KORMOP CO.LTD

53/1, Block No-C, Ward No-3, Belma Ashulia, Bangladesh

24 February 2025

Observation 2: Lack of lateral stability and absence of design documents (Factory Building-1).

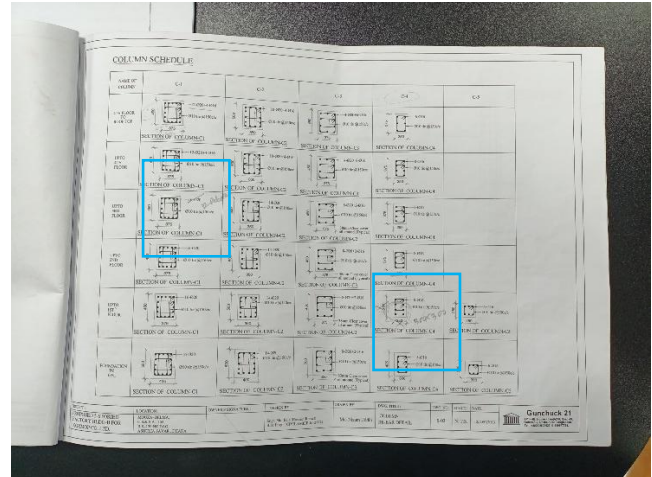
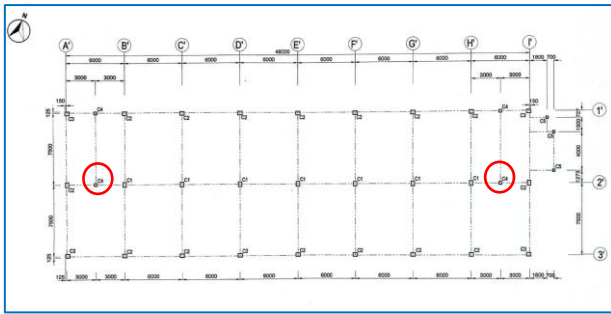
Description: Lateral load transfer media (compression struts) were found missing. So, stability in the long direction is incomplete. The building engineer is required to carry out Detail Engineering Assessment (DEA) to check the stability system for the whole structure and suggest proper remedial measures.

Observation-3: Mismatches in as-built drawings (Factory Building-2).

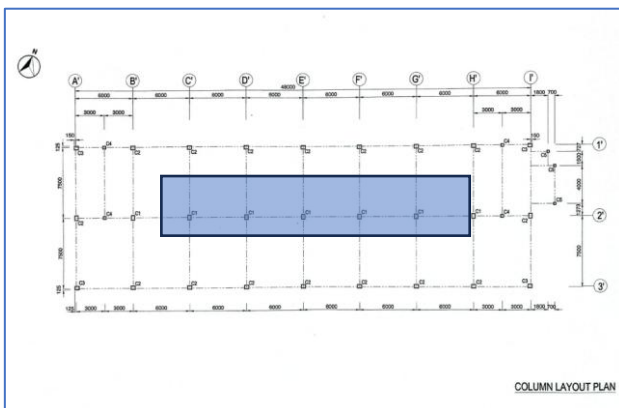
Description: Size and amount of rebar in C-4 column did not match with onsite condition. 300x300 mm was found instead of 250x375 and 6 nos of rebars were found instead of 8 nos. Also, the amount of rebar at C-1 column on 3rd floor were found less than the drawings. Building engineer is required to survey the whole structure and prepare accurate as-built drawings for the structure.
